HIGHWAY 90 - INTERSTATE HIGHWAY 10 **BUSINESS PARK SUBDIVISION**

APPLICATION NUMBER 16 DATE August 7, 2008
APPLICANT Highway 90 - Interstate Highway 10 Business Park Subdivision
REQUEST Subdivision

DETAIL SITE PLAN

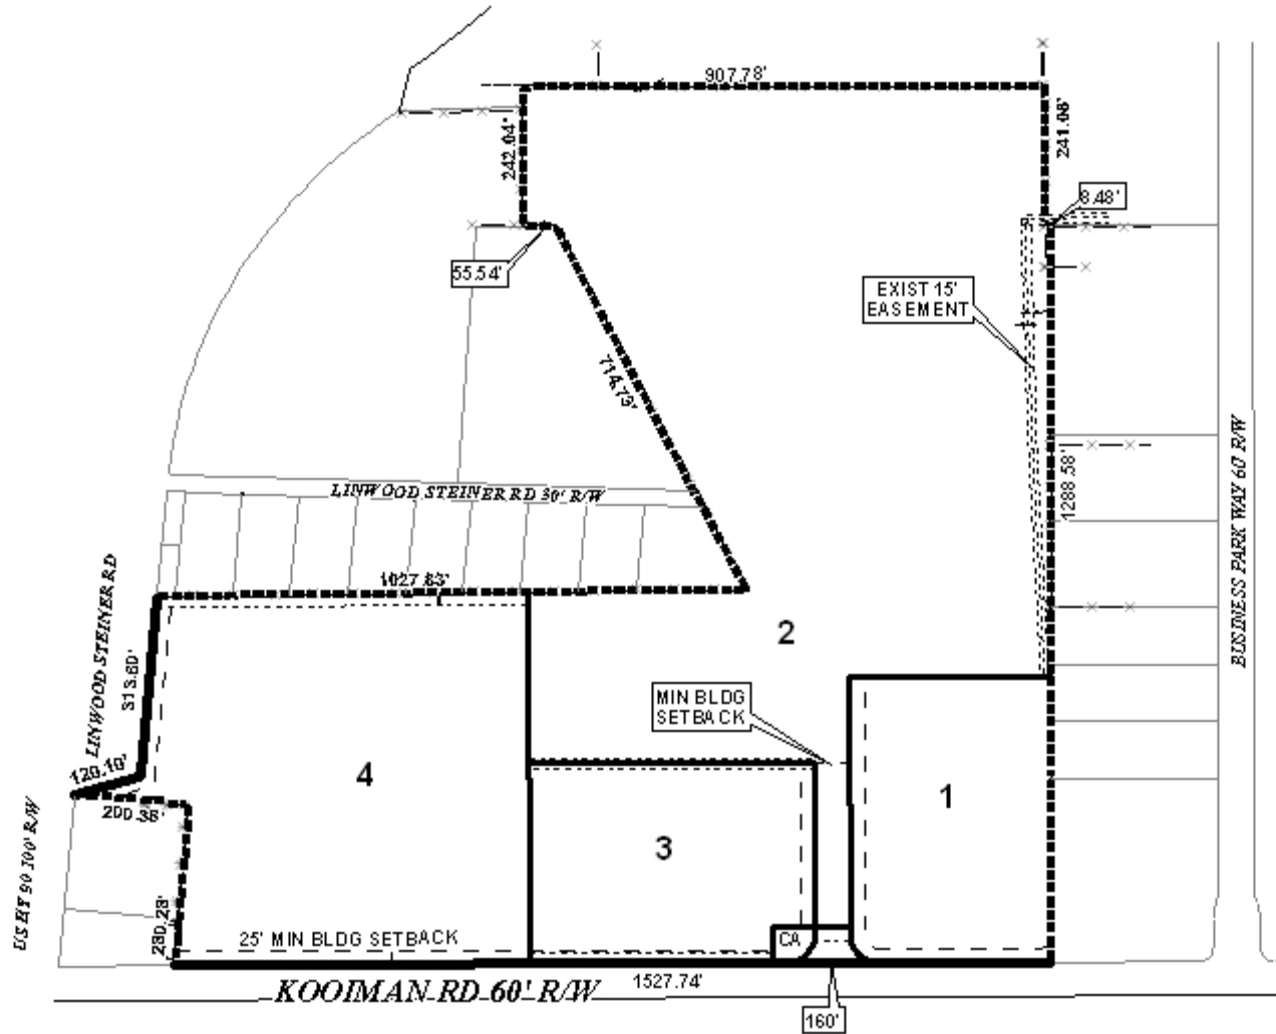
Proposed lots 1, 3 and 4 have a minimum of 299 feet of frontage onto a road, while proposed lot 2 only has 60 feet (160 feet with radii) of frontage. Lot 4, additionally, is a corner lot, with frontage on two roads. It is recommended that lots 1 and 3 be limited to two curb-cuts each, that lot 4 be limited to two curb-cuts onto Kooiman Road and one curb-cut onto Barry Drive (due to its nearby intersection with U. S. Highway 90), and that lot 2 be limited to one curb-cut, with the size, design and location of all curb-cuts to be approved by Mobile County Engineering (and ALDOT for the Barry Drive/US Highway 90 curb-cut), and comply with AASHTO standards.

The frontage of lot 2 on Kooiman Road is designed to allow for the construction of a road into the lot, thus a note should be placed on the plat stating that no additional subdivision of lot 2 shall be allowed until additional frontage on a public street is provided.

Linwood Steiner Road stubs into proposed lot 2, it appears that access is not intended due to a proposed privacy fence between the subdivision site and the residences located on Linwood

Steiner Road. A note should be placed on the final plat, if approved, stating that all lots are denied access to Linwood Steiner Road.

The 25-foot minimum building setback line is depicted on the plat, however, it should be adjusted for lot 2 so that a "box" occurs where Linwood Steiner Road stubs into the site, and where the pole of lot 2 meets the "flag" portion of the site.

A common area is depicted on the plat. The note on the preliminary plat stating that maintenance shall be the responsibility of property owners should be retained for the final plat, if approved.

Residences abut the site. Any commercial development within the proposed subdivision will be required to provide a buffer which complies with Section V.A.7. of the Subdivision Regulations, and such a buffer is depicted on the preliminary plat, as is a note. The note and buffer should also be placed on the final plat, if approved.

- 1) Placement of a note on the final plat stating that lots 1 and 3 are limited to two curb-cuts each;
- 2) Placement of a note on the final plat stating that lot 4 is limited to two curb-cuts onto Kooiman Road, and one curb-cut onto Barry Drive;
- 3) Placement of a note on the final plat stating that lot 2 is limited to one curb-cut, and that no future subdivision of lot 2 shall be allowed until additional frontage on a public street is provided via the construction of a road;
- 4) Placement of a note on the final plat stating that the size, design and location of all curb-cuts are to be approved by Mobile County Engineering (and ALDOT for Barry Drive), and to conform to AASHTO standards;
- 5) Placement of a note on the plat stating that all lots are denied access to Linwood Steiner Road;

- 6) Revision of the 25-foot minimum building setback line for lot 2 so that a “box” occurs where Linwood Steiner Road stubs into the lot, and where the pole of lot 2 meets the “flag” portion of the lot;

- 8) Retaining of the note stating that the maintenance of the depicted common area detention facilities is the responsibility of the property owners;
- 9) Placement of a note on the plat stating that the site must be developed in compliance with all local, state and Federal regulations regarding endangered, threatened or otherwise protected species; and

- 10) Placement of a note on the final plat, as depicted on the preliminary plat, stating that any lots which are developed commercially and adjoin residentially developed property must provide a buffer, in compliance with Section V.A.7 of the Subdivision Regulations.
